**CHARTER TOWNSHIP OF VAN BUREN
PLANNING COMMISSION AGENDA
Wednesday, March 9, 2022 – 7:30 PM
Van Buren Township Hall
46425 Tyler Road**

**Subject: VBT-21-043 Applebee's/ 10526 Belleville Road; Site Plan Review #2;
Revised Site Plans Dated February 11, 2022.**

Applebee's Addition – To-Go Booth Construction Plan Engineering and Final Site Plan Review

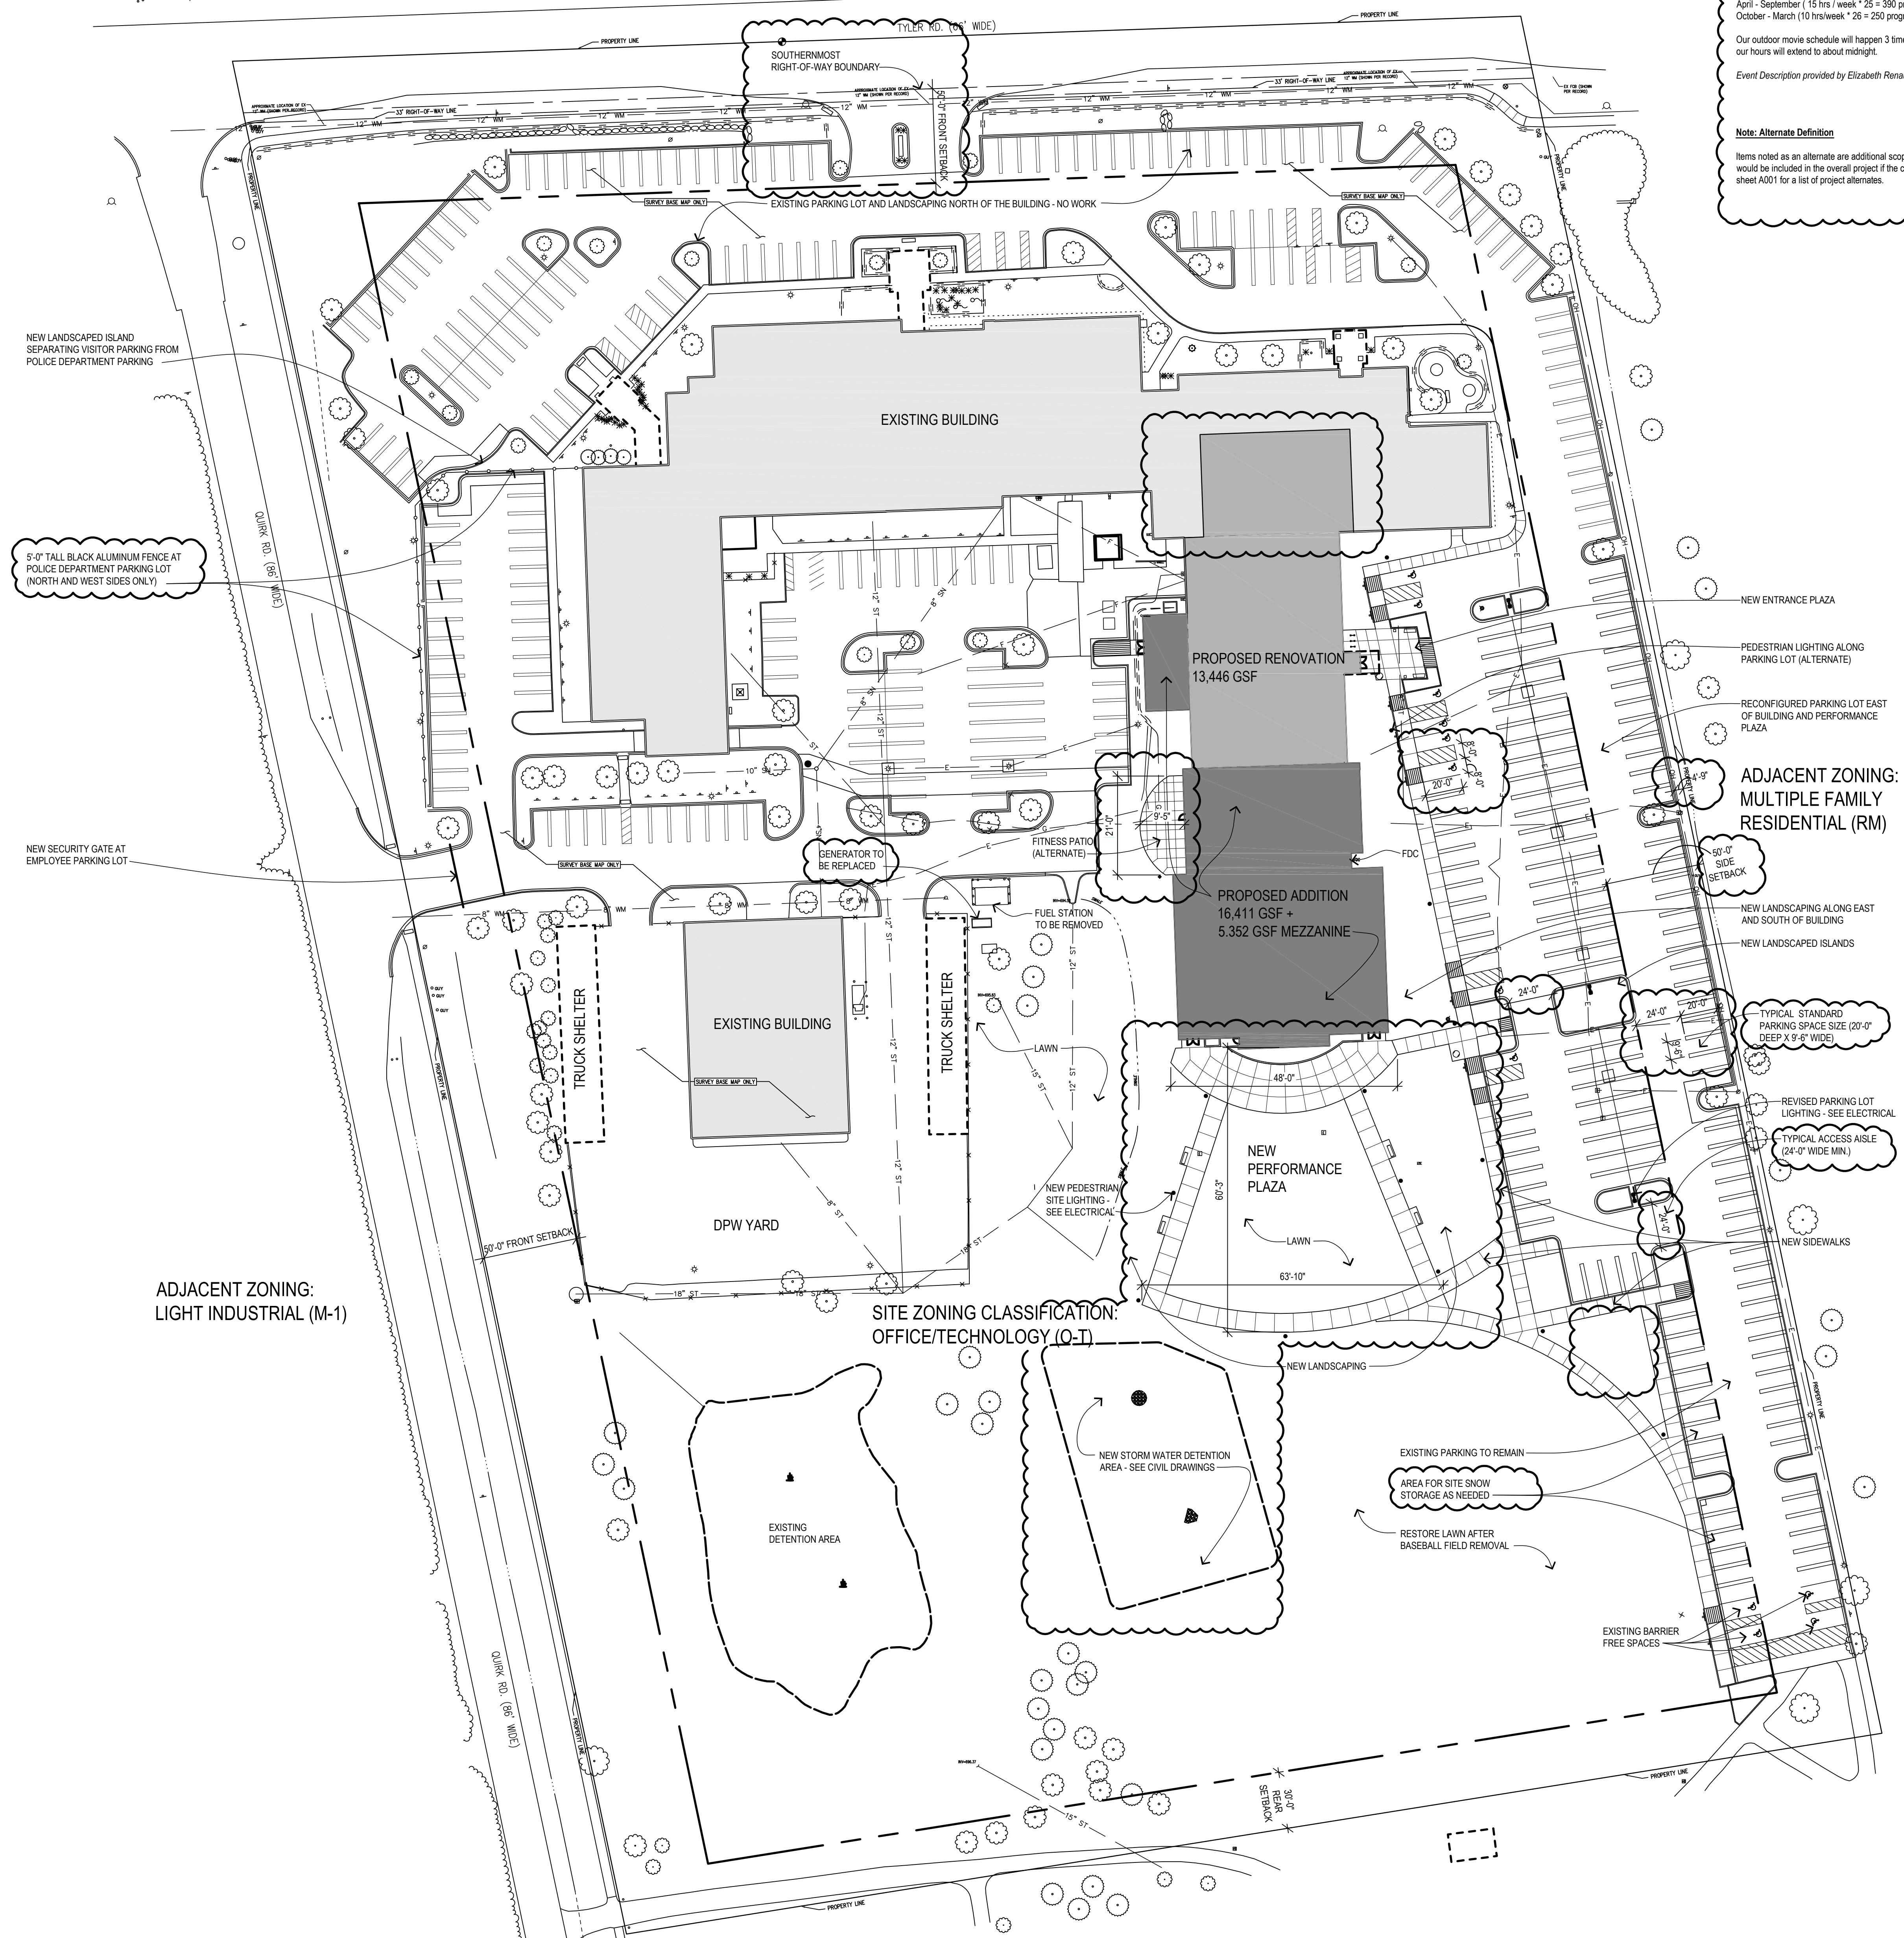
The required fire flow and spacing of the fire hydrants for the type of construction and square footage of the building complies with the fire code. **However, the Fire Department Connection (FDC) on sheet C3.2 is obstructed by vehicle parking. The FDC needs to be moved to the southeast corner of the building by the hydrant, or 1 parking space in front of the FDC will need to be eliminated and marked accordingly.**

NORTH
1
AS101
ARCHITECTURAL SITE PLAN
SCALE: 1" = 40'-0"
SCALE: 1" = 40'-0"

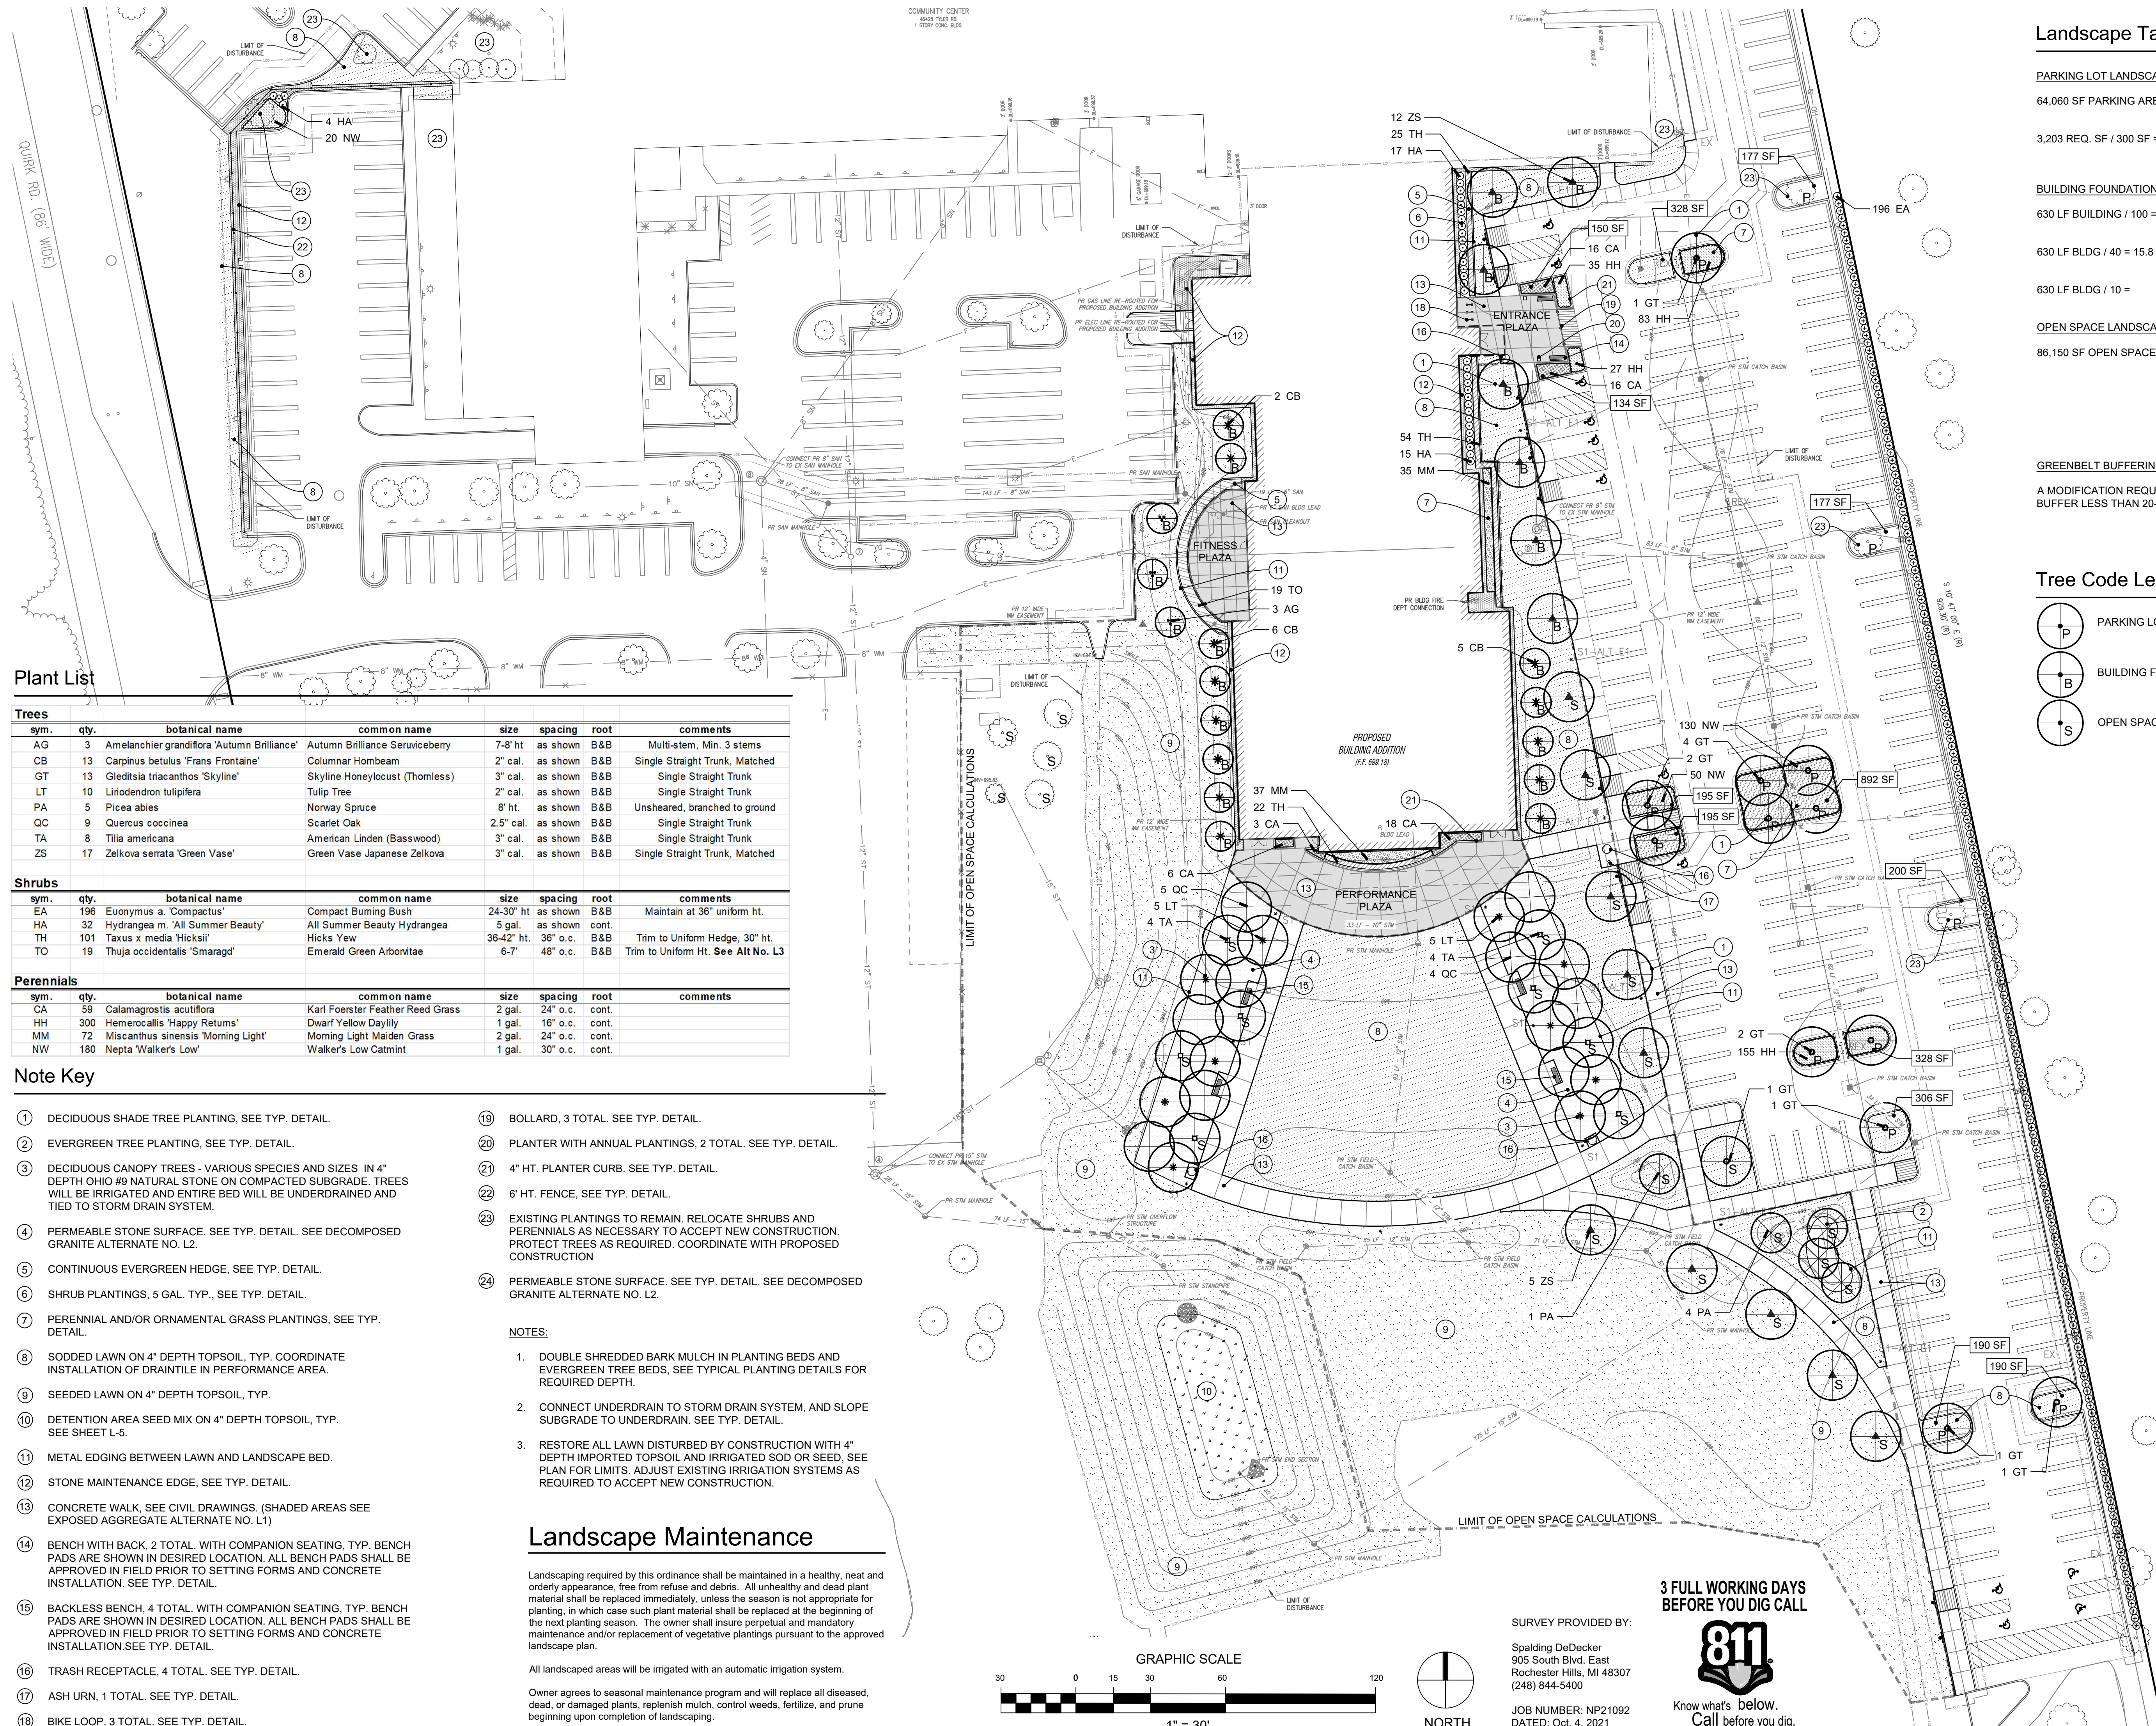
Fencing. New security fencing and a gate is proposed to provide only secure access for employee parking at the entrance to the site on Tyler Road. The proposed fence is a 5' tall black aluminum fence. A fencing detail has been provided on sheet L-5. The proposed gate must be shown on a detail as well.

N/S Response: Refer to landscape sheet L-5. The fence has been changed to 5-foot tall from 6-foot tall per owner's request.
